Item 4.**Development Application: Site 15, 77-93 Portman Street, Zetland**

File No.: D/2018/517

Summary

Figure 24: Change in link bridge design: as originally submitted (L) and as revised (R).

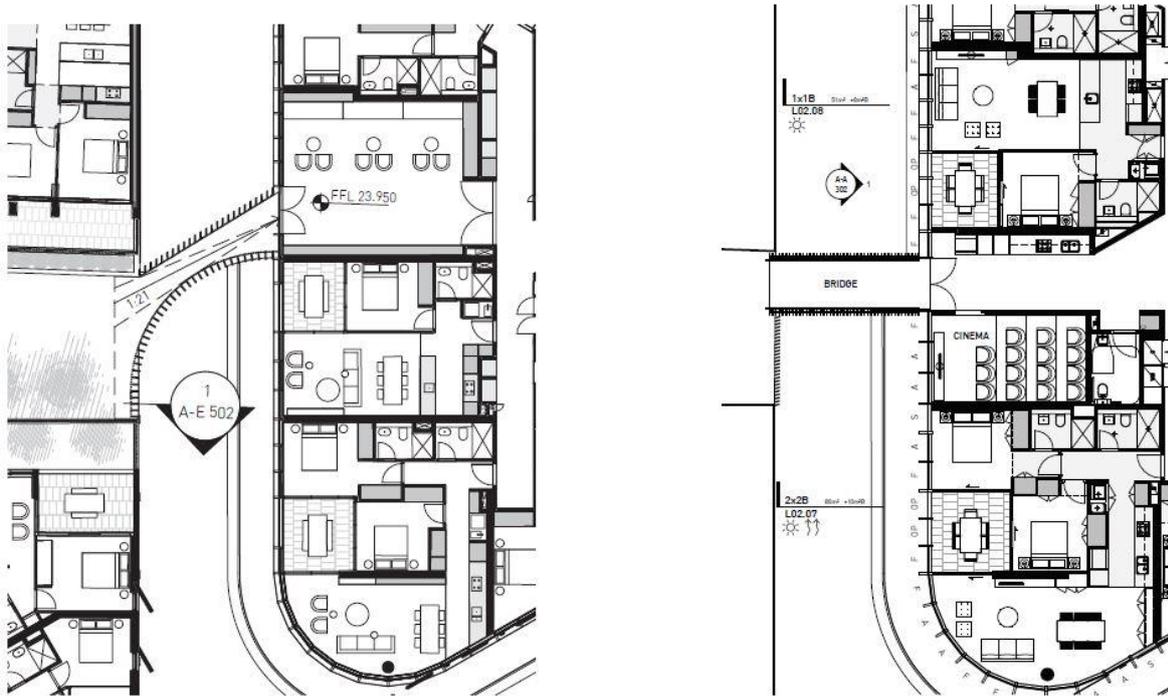
- (iii) Review the use of full height glazing to south facade to ensure appropriate privacy is provided; and
 - (iv) Provide increased setbacks to level 5 or 6 at eastern end of building.
- (c) Building C:
- (i) A review of materials to reconsider the proposed grey flinty brick with a livelier brick colour.
- (d) Building D:
- (i) Reconsider window arrangement towards through site link.
- (e) Public domain:
- (i) Recommend decluttering of the through site link with relocation of bicycle parking and furniture; and
 - (ii) Review of overhead bridge link to minimise its bulk.

18. In response to these comments, a revised scheme and sketches were submitted in February 2019. A summary of the key amendments made is as follows:
- (i) Through site link and overhead bridge link redesigned and rationalised;
 - (ii) Ground floor apartments of Building A deleted and replaced with retail;
 - (iii) 350mm fins to Building A;
 - (iv) Building A building expression revisited, slots on southern facade re-instated;
 - (v) Building B setback to through site link above Level 5;
 - (vi) Building B materiality and building expression reviewed;
 - (vii) Building C materiality reviewed; and
 - (viii) Building D apartments replaced with 7 x 4 storey terrace style apartments.

Figure 32: Extent of area for height variation for Building A shown in roof plan dashed red.

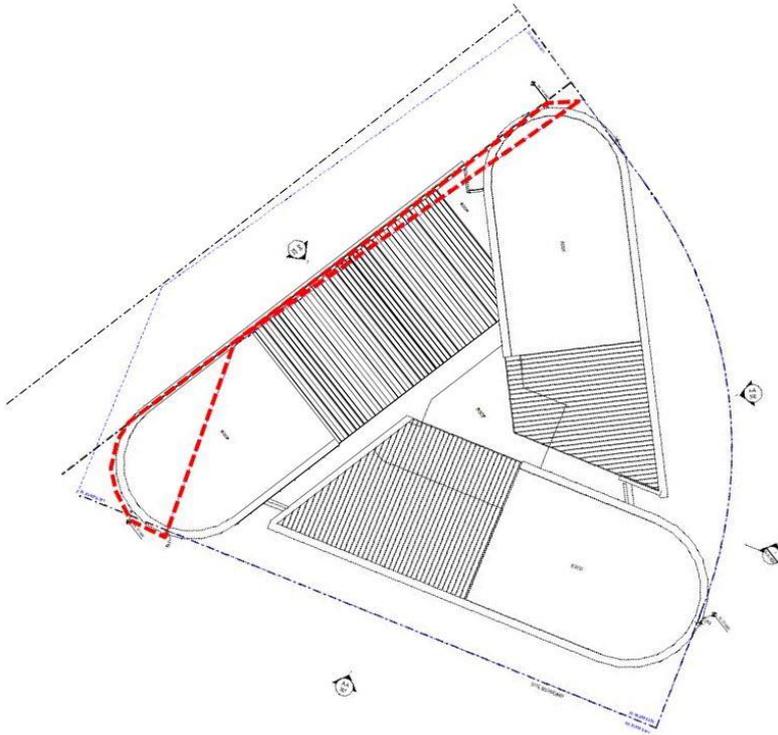
- (a) Building A: With an RL 98 this section of the site is intended to contain the highest building on the site. The proposal conforms with this intent. The proposed development includes a straightening of the through site link (noted as a design opportunity within the design competition brief) which results in Building A encroaching laterally into the adjoining RL 22 height area. The height of RL 98 is proposed as a maximum height across the building. The extent of the area in which the height is breached is across a small section of the north and western ends of the building as shown in the figure below. The extent of the lateral variation is 76m, a variance of 345%.

Figure 33: Extent of area for height variation for Building B shown in roof plan dashed red.

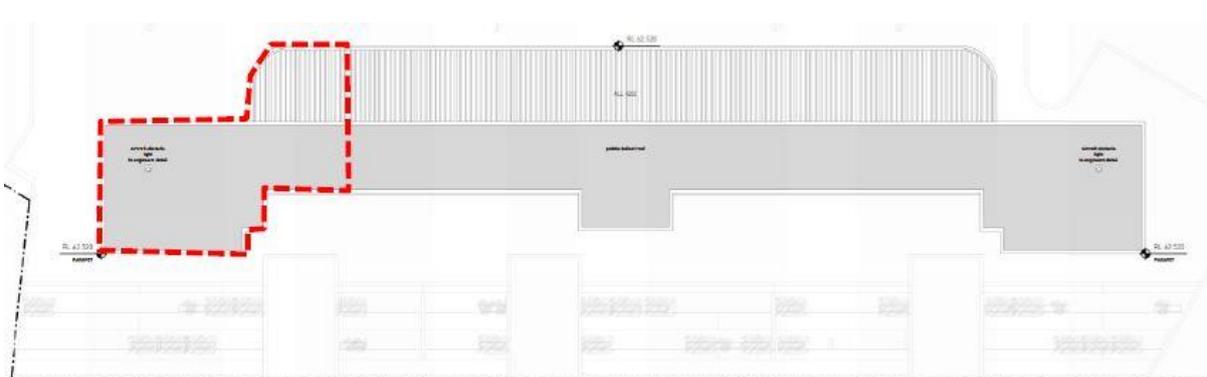
- (b) Building B: The Building C envelope has been reduced and the Building B frontage across Zetland Avenue has expanded, resulting in Building B being situated across the RL 62 and RL 63 height areas. A height of RL 63 is proposed as a consistent height across the building, resulting in a breach within the RL 62 height area. The extent of the variation is 1m, a variance of 1.6%.

Figure 38: Typical kitchen perspective detail drawing.

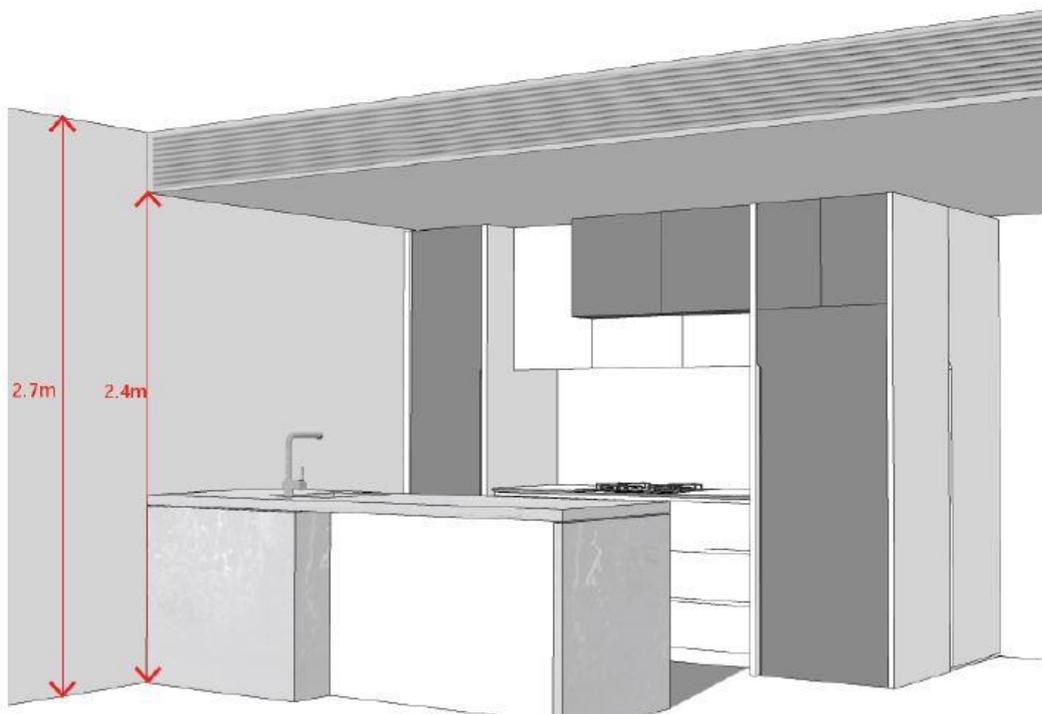
- (b) 2.4m minimum ceiling height for non-habitable rooms; and
 - (c) 3.3m minimum ceiling height on the ground and first floor in mixed use areas.
60. For the residential apartments in Buildings A, B and C, a compliant floor to ceiling height of 2.7m is provided to all living and sleeping areas, however a ceiling height of 2.4m is proposed to kitchen areas. The lower ceiling height allows for building service infrastructure including vents, conduits, and plumbing to be located in a centralised and accessible location within the apartment. An illustration of the typical kitchen ceiling is provided below:

61. For the ground floor, the ceiling heights have been designed to comply with Part 4.1 of GSTC DCP 2012 which specifies a minimum floor to ceiling height of 3m
62. The first floor apartments provide ceiling heights consistent with those above being 2.4 to 2.7m high.

Figure 39: Extract from landscape DA report.

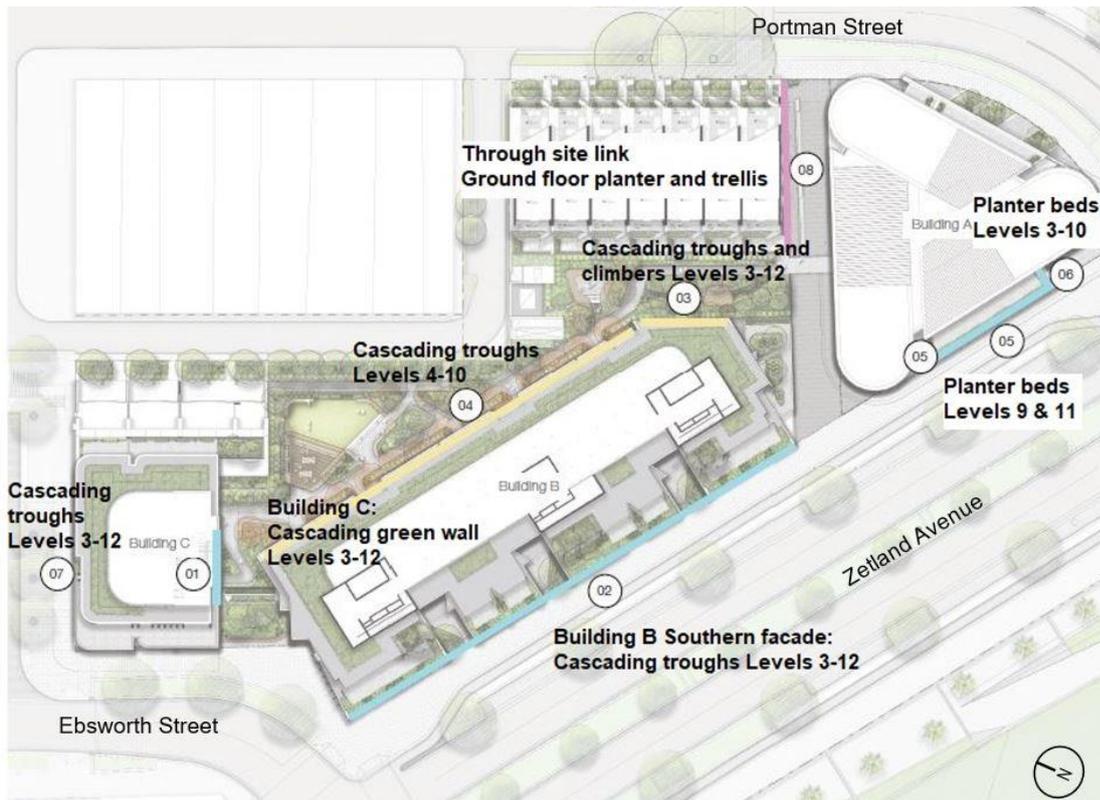
76. The submission includes a revised landscaping plan incorporating a green wall to the eastern side of Building C, planter beds, cascading troughs and climbers as shown in the figure below.

Figure 51: Building separation between Building D (L4) and Building A (L5).

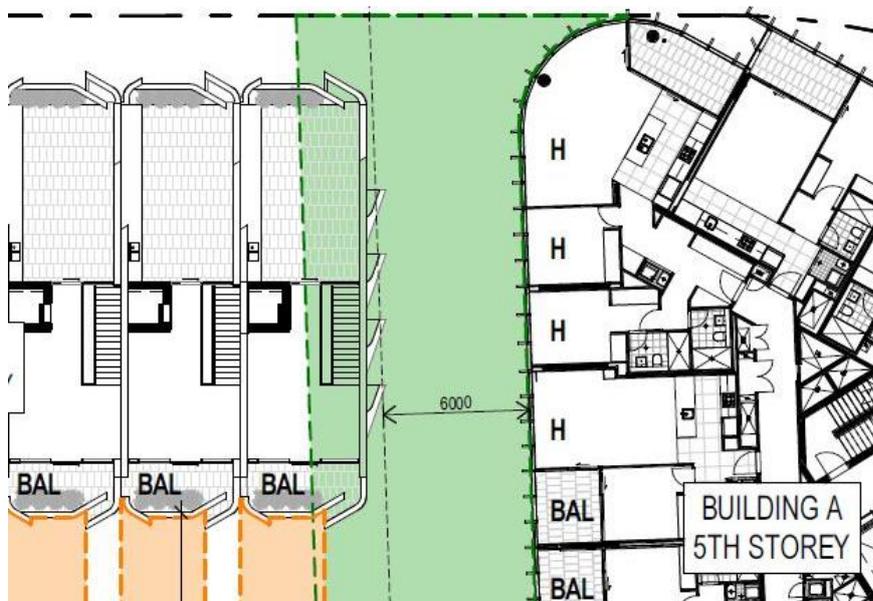
89. Building separation of 6m is proposed rather than an ADG compliant 12m. Privacy is achieved with angled windows, and 1.8m bladed parapet to the Building D terrace.

Figure 52: Building separation between Building D (L4) and Building B (L4).

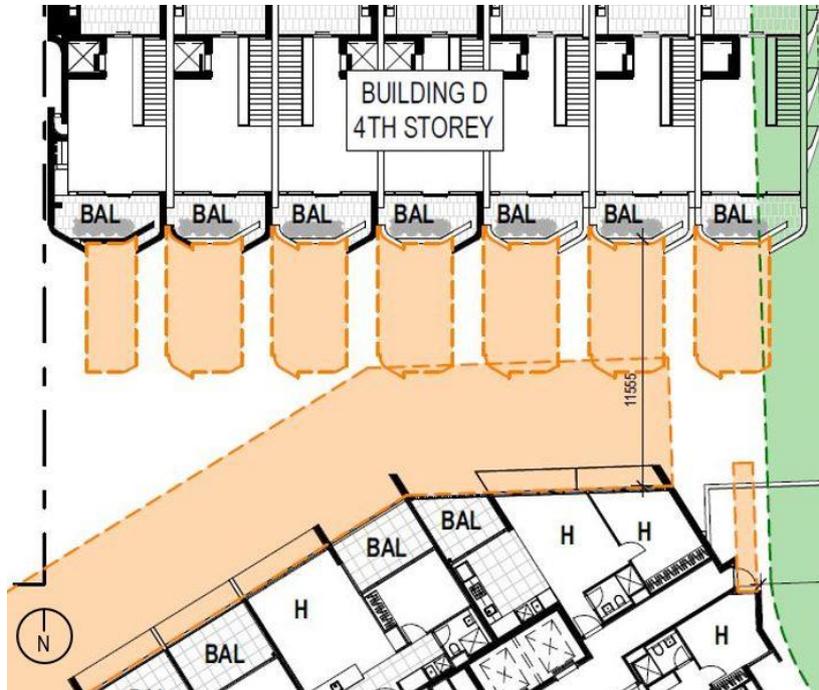
90. The building separation is generally a compliant 12m or greater. Three Building D dwellings are set back between 11.4m to 11.55m for the Building D fourth storey. Privacy is achieved through the angled facade of Building D and plantings to the balcony edges of both buildings.

Figure 53: Section drawing of building separation between Building A and B.

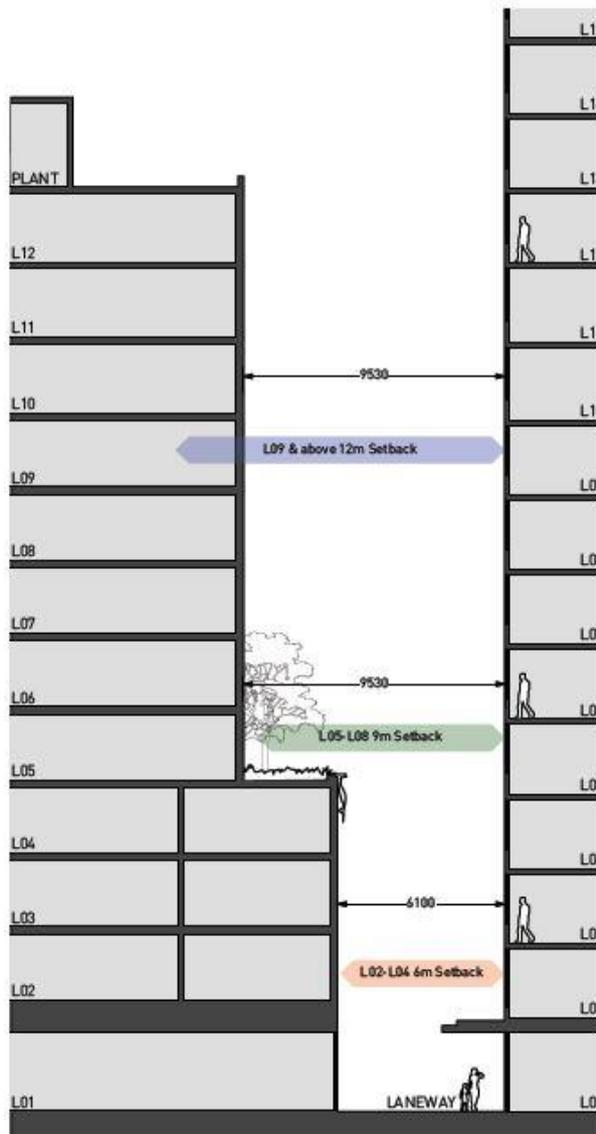
91. For Levels 2 to 4, a building separation of 6.1m is provided between habitable rooms and/or balconies rather than an ADG compliant 12m. Privacy is provided by windows on Building B not facing towards Building A and parapets to the eastern balconies of Building B directing overlooking away from Building A.
92. For Levels 5 to 8, a building separation of 9.5m is provided between habitable rooms, rather than an ADG compliant 18m. Privacy is provided by windows on Building B not facing towards Building A.
93. For Levels 9 to 12, a building a building separation of 9.5m is provided between habitable rooms rather than an ADG compliant 24m. Privacy is provided by windows on Building B not facing toward Building A.

Figure 55: Separation drawing for Levels 5 to 8 Buildings B & C.

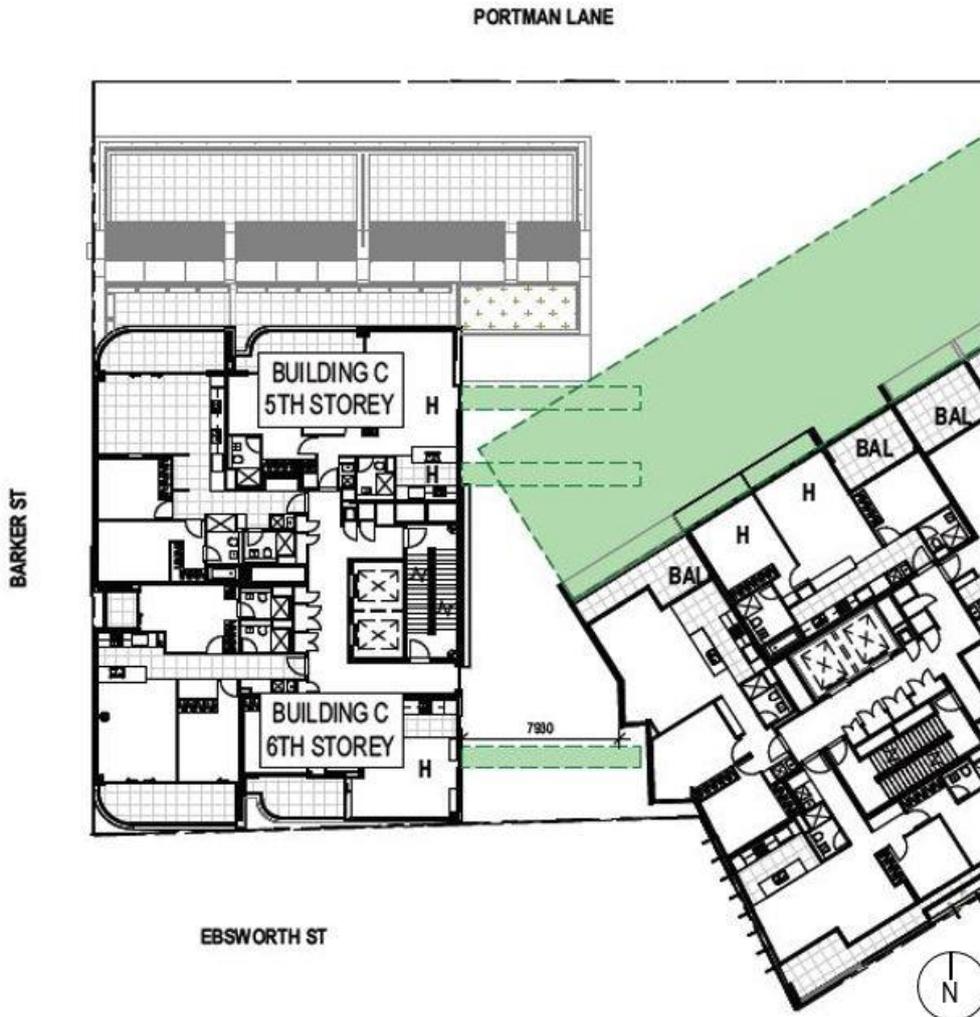
98. Levels 11 to 12: a setback of 9.3m is provided, between habitable to habitable rooms/balconies rather than an ADG compliant 24m. Privacy is provided by the provision of narrow slot windows on the eastern facade of Building C. These narrow windows are provided to kitchen and secondary windows to living rooms that have a primary orientation to Portman Lane. Bedrooms on Levels 11 and 12 of Building B have windows to the south elevation.
